ADDENDUM NO. 3

PROJECT : ***Bay District Schools
Rosenwald Building #2 Remodeling***

This Addendum #01 consists of Items 1.1 through 1.3:

Item 1.2 - Mechanical Fencing Details (RFI 51 Answer)

WEST MECH UNITS
SCALE: 1/8" = 1'-0"
NORTH

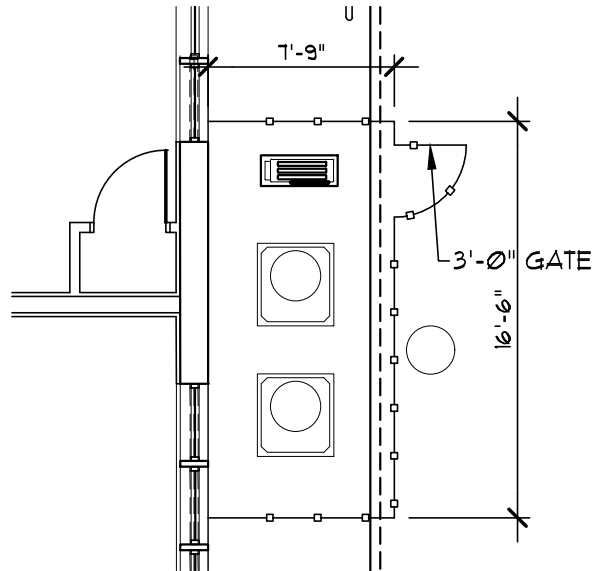
51	I am attempting to get a fencing quote for Rosenwald for the (2) south mechanical pad fence and gate and the (1) on the west side for the one in the parking lot. I unfortunately do not have the fencing dimensions provided on the drawings. Do you mind sending those over as soon as you can? 05/12/2026	02A	Please see fencing detail
52	CC.02.011 Rack Elevation on T6.1 does not show location of the 2 Valcom VE8002BR, are these to be wall mounted? 5.12.26	17A	Locate on the equipment shelf adjacent
53	T5.1 indicates on intercom notes 15 and 16 that existing gymnasium speakers to be re-routed to this closet. a. Will the ve8002BR and VP-6124 they were connected to originally be relocated to this closet as well? b. If not, are the two 8002 and single VP-6124 enough to power/supply them in addition to the new speakers? c. What are the speaker counts/types of existing lines referenced in 15 and 16? 5.12.26	17A	A. The new 8002 should be enough, but reuse the existing if necessary. B. See response in a. above. C. Get someone on the ground to verify. D. Use the one in the bottom left and also confirm with BDS on their color code. Disregard the one located below the raceway symbols.

NOTE:
FENCING DIMENSIONS ARE APPROXIMATE AND ARE TO BE FIELD VERIFIED TO PROVIDE MINIMUM CLEARANCES AROUND MECHANICAL UNITS AND TO VERIFY SITE CONDITIONS
